1 **Request IR-1:**

3 **Please refer to the footnote on page 11 of document N-1, the 2017 ACE Plan, regarding the**  
4 **federal government's recent carbon policy announcement:**

2017 Annual Capital Expenditure Plan (NSUARB M07745)  
NSPI Responses to SBA Information Requests

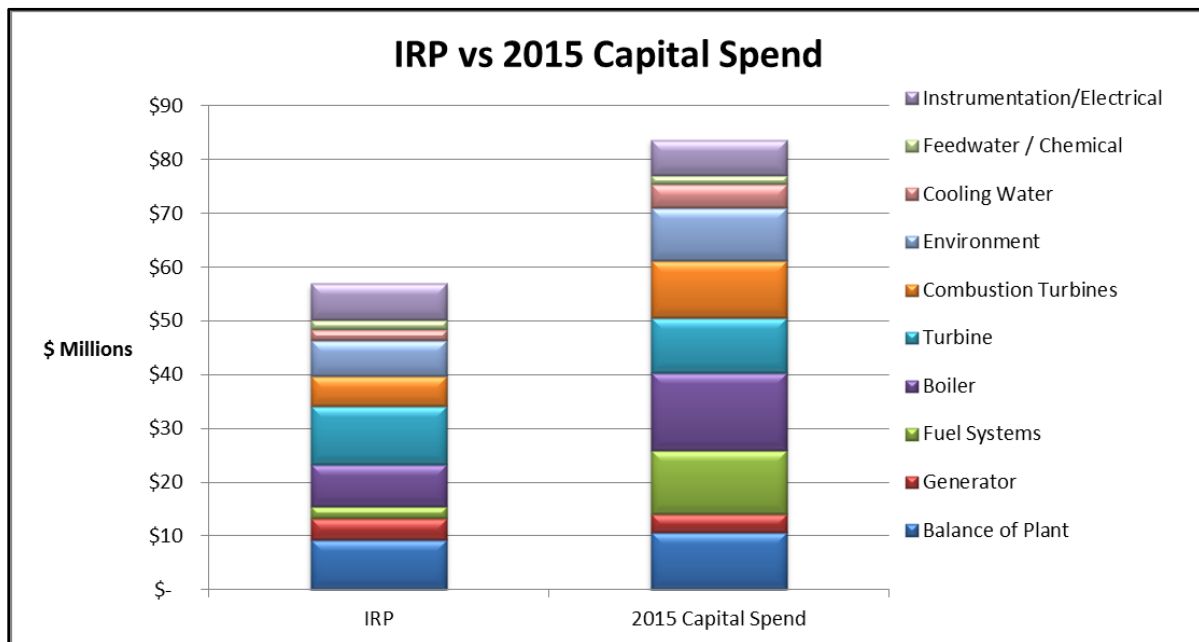
3 **Please refer to the chart on page 103 of document N-1, the 2017 ACE Plan. Please provide**  
4 **similar charts showing projected annual investment per the IRP and actual spending for**  
5 **each of years 2015 and 2016.**

9 Please refer to the charts below for IRP comparisons to 2015 actual capital spend and 2016  
10 forecasted capital spend. As discussed in the 2017 ACE Plan, the 2014 IRP was completed using  
11 only 2014 dollars and did not include any form of inflation for future years and was at a time  
12 where the Canadian dollar was relatively on par with the US dollar. When applied to the 2014  
13 IRP forecast, a conservative estimate of the increase in that forecast would be \$6 million.

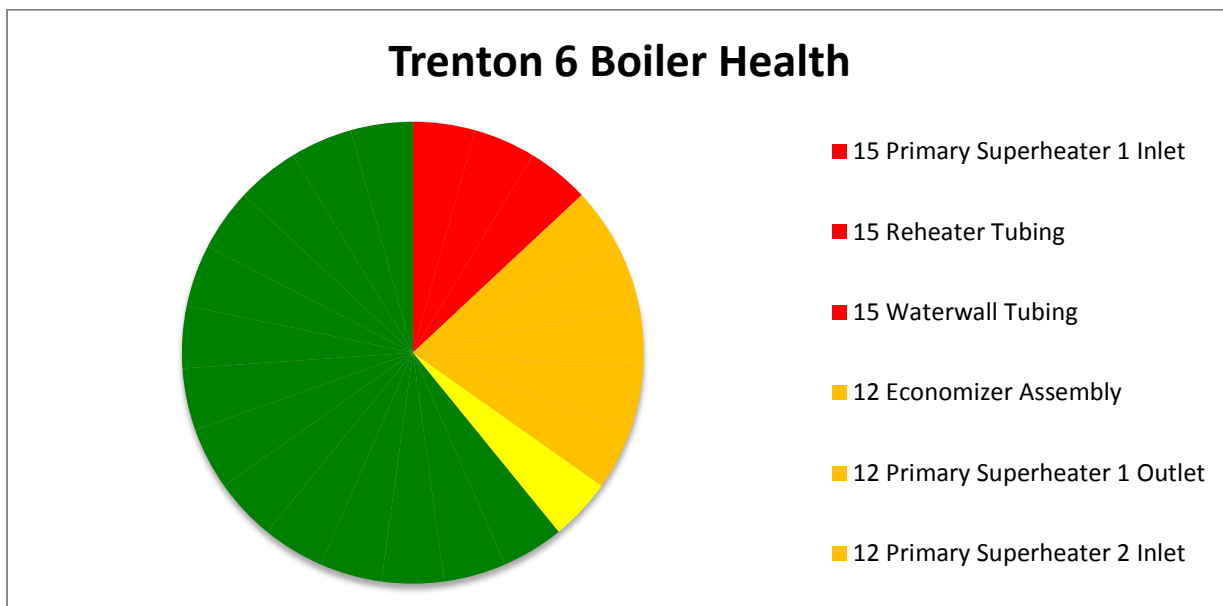
3 **For CI# 49533—TRE6 Boiler Refurbishment: Please provide all supporting documentation**  
4 **that shows that the boiler will need to be refurbished.**

8 The figure below shows the health assessment of Trenton Unit 6 boiler. Consistent with NS  
9 Power’s asset management risk ranking methodology, each piece of major equipment is  
10 evaluated on condition (1-5) and criticality (1-5) to produce a risk ranking (1-25). These risk  
11 rankings are displayed graphically below to demonstrate the overall health of the boiler.  
12 Sections of the boiler that have been evaluated to be in very poor condition are shown in red,  
13 while sections which were evaluated to be in acceptable condition are shown in green and are not  
14 detailed fully in the graph below.

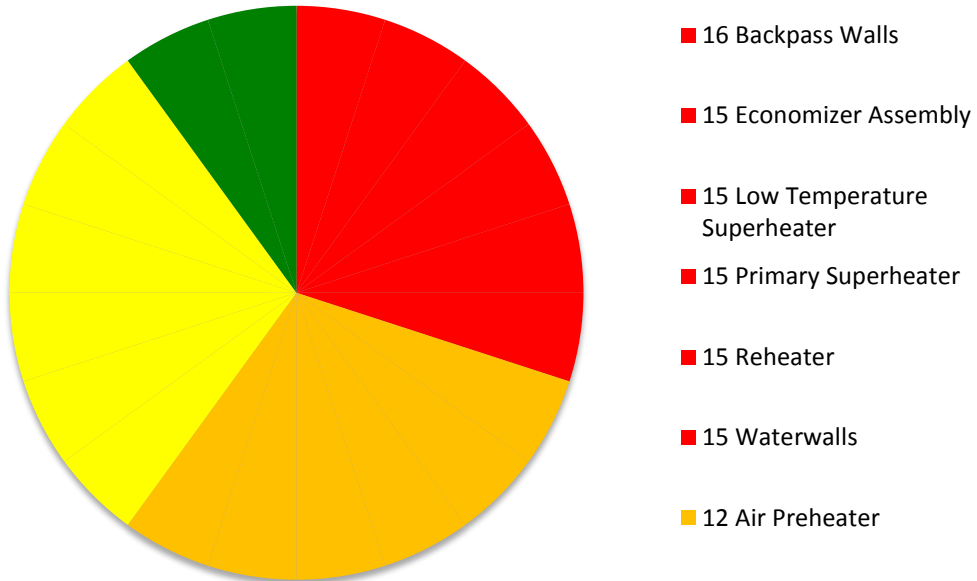
3 **For CI# 49419—POT Boiler Refurbishment 2017: Please provide all supporting**  
4 **documentation that shows that the boiler will need to be refurbished.**

8 The figure below shows the health assessment of Point Tupper Unit 2 Boiler. Consistent with  
9 our asset management risk ranking methodology, each piece of major equipment is evaluated on  
10 condition (1-5) and criticality (1-5) to produce a risk ranking (1-25). These risk rankings are  
11 displayed graphically to show the overall health of asset. The condition assessments were  
12 completed by industry experts with collaboration with internal subject matter experts. The  
13 economizer assembly, superheater, reheater and waterwall tubing yielded a risk ranking above  
14 15. These sections require selective tube and piping repairs to maintain minimum wall thickness  
15 corresponding to American Society of Mechanical Engineers (ASME) specifications. Please  
16 refer to Attachment 1 for a summary of outage inspections and recommendations completed by  
17 the boiler original equipment manufacturer.

19 The figure below is a graphical representation of the Point Tupper Unit 2 boiler health. The  
20 areas of the chart represent the risk rating of the various boiler components (Red representing the  
21 greatest risk, Green representing the least risk) to provide visual summary of the overall asset  
22 condition and an indication of the number of components that require mitigating measures.

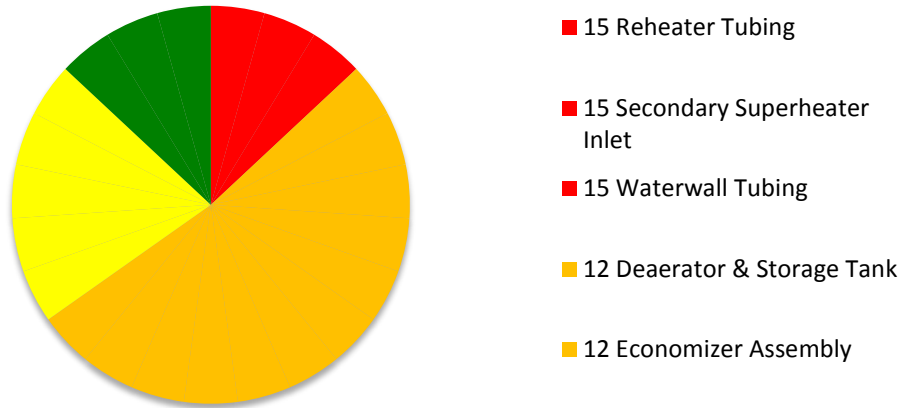
3 **For CI# 49536—TRE5 Boiler Refurbishment 2017: Please provide all supporting**  
4 **documentation that shows that the boiler will need to be refurbished**

8 The figure below shows the health assessment of Trenton 5 Boiler. Consistent with our asset  
9 management risk ranking methodology, each piece of major equipment is evaluated on condition  
10 (1-5) and criticality (1-5) to produce a risk ranking (1-25). These risk rankings are displayed  
11 graphically to show the overall health of asset. The condition assessments were completed by  
12 industry experts with collaboration with internal subject matter experts. Sections of the  
13 superheater, reheater and waterwall tubing yielded a risk ranking of 15. These sections require  
14 selective tube repairs to maintain minimum wall thickness corresponding to American Society of  
15 Mechanical Engineers (ASME) specifications. Please refer to Attachment 1 for a summary of  
16 outage inspections and recommendations completed by the boiler original equipment  
17 manufacturer.

19 The figure below is a graphical representation of the Point Tupper Unit 2 boiler health. The  
20 areas of the chart represent the risk rating of the various boiler components (Red representing the  
21 greatest risk, Green representing the least risk) to provide visual summary of the overall asset  
22 condition and an indication of the number of components that require mitigating measures.
